# Validation Checklist

Lodgement Number : **LDG-069364-24**  
Case Number: **ABP-318689-23**  
Customer: **Michael Mahon and Regina Hctor**  
Lodgement Date: **18/01/2024 11:28:00**  
Validation Officer: **Daniel O'Connor**  
PA Name: **Tipperary County Council**  
PA Reg Ref: **2360763**  
Case Type: **Normal Planning Appeal PDA2000**  
Lodgement Type: **Observation / Submission**

An Bord Pleanála Case reference: PL92.318689

Description of Development: The construction of 7 no. wind turbines and associated works.

Fig 2

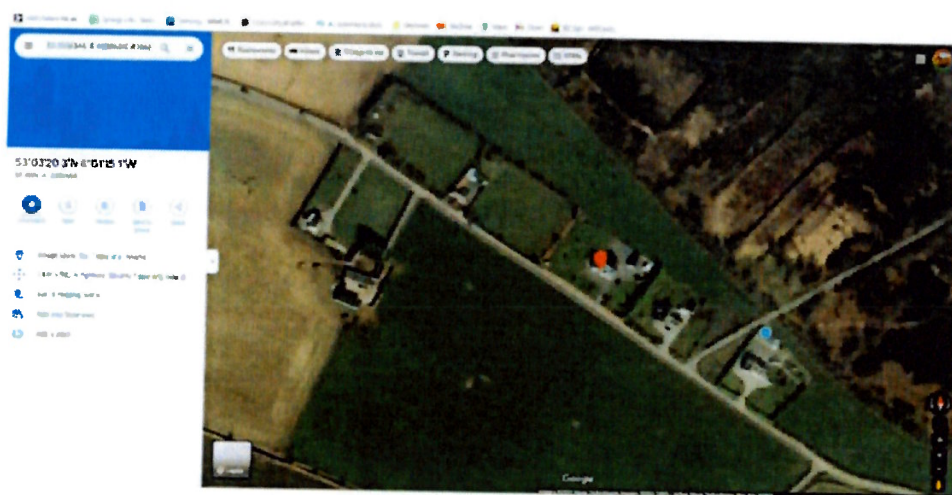
However, the measurements applied are flawed on several points. **Firstly, the measurements were taken to the center of the household and not to the nearest point of the curtilage of any residential property.** An example is shown for household 37 in Fig 2, using the ITM coordinates used by the applicant.

If we use coordinates based on the nearest point of curtilage to the center of the wind turbines, then 2 households (37 and 51) are below the minimum setback requirement for a Turbine tip height of the lowest proposed wind Turbine blade tip height of 179.5m x 4 = 718m. A further 4 households (4,14,36,52) are below the minimum setback requirement for a Turbine tip height of the tallest proposed wind turbine blade tip height of 185m x 4 = 740m. See Table 2 for reference.

Fig.3

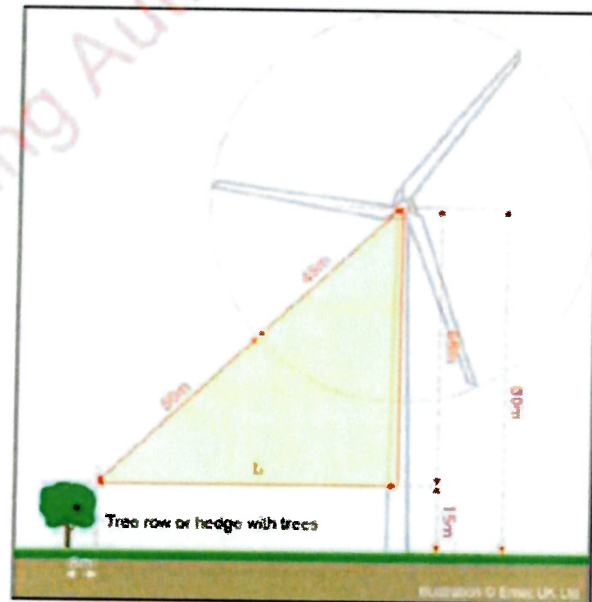
The applicant themselves have applied this method when calculating other sensitive receptors by using the following receptor buffer calculation in determining the required buffer zone distance for Bats in "EIAR Appendix 6-2 Bat report" (Fig 3):

By applying the same method of calculation, we can then calculate the required horizontal distance required to maintain the required setback distance for other sensitive receptors (Households) to the nearest point of Curtilage of each household. For the calculation we will make one assumption that the curtilage feature has height of 1.5 meters (Typical hedge height).

Fig 4 example of household 37 calculation

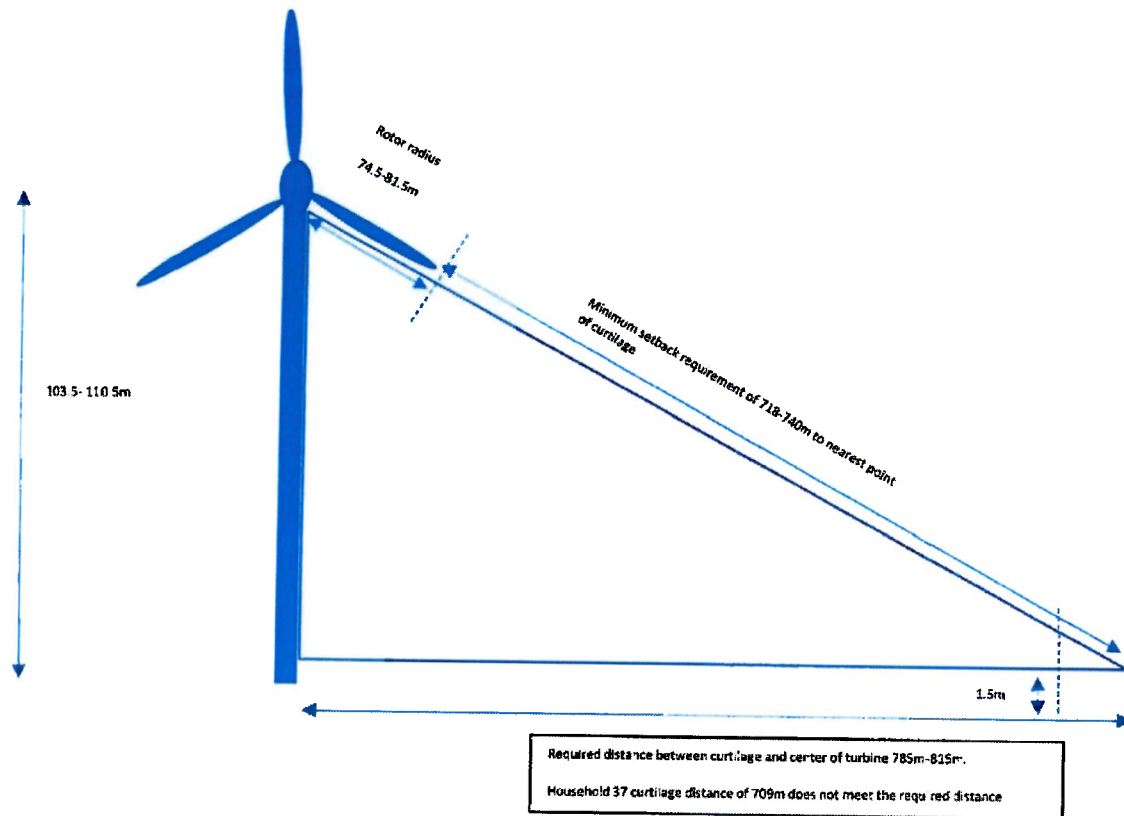
There are 4 possible configurations (Hub height and rotor diameter) set out and using the above calculations the separation distance required from all 4 vary between **785m and 815m** depending on configuration.

Taking this into account and based on the nearest point of the turbine structure being the turbine blade, it can be calculated (see Table 3) that the following 11 households (4,5,8,14,36,37,42,44,51,52,18) falls below the minimum separation distance to achieve the setback requirement of 718m and 740m by a significant amount and household 35 falls below the minimum separation distance to achieve the setback requirement of 740m.
